Application No: 140290/FH/2024

Location: 24 Amherst Road, M20 4NS

Proposal: Minor extension to the dwelling, including an outbuilding containing a living area.

Figure 2. Appendix D of the report. Undefended levels

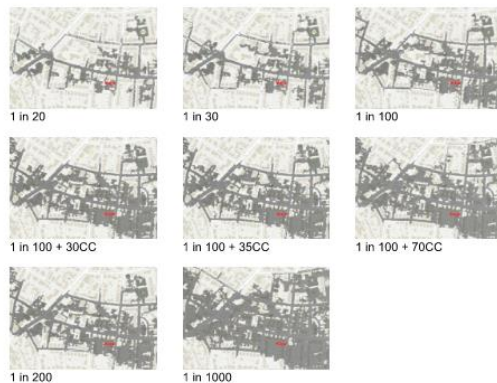
Following your recent query concerning the inclusion of undefended flood levels in the Flood Risk Assessment report, I would like to confirm that the information requested by MCC Planning has been thoroughly addressed within the report.

Specifically, the undefended flood levels you referred to are clearly presented in Section 5.5, Page 8 of the report (version 1) dated August 24. These levels align with the concerns raised by MCC Planning and were correctly incorporated during the initial preparation of the document. As such, we believe the report comprehensively covered the information sought and that this matter has been appropriately addressed.
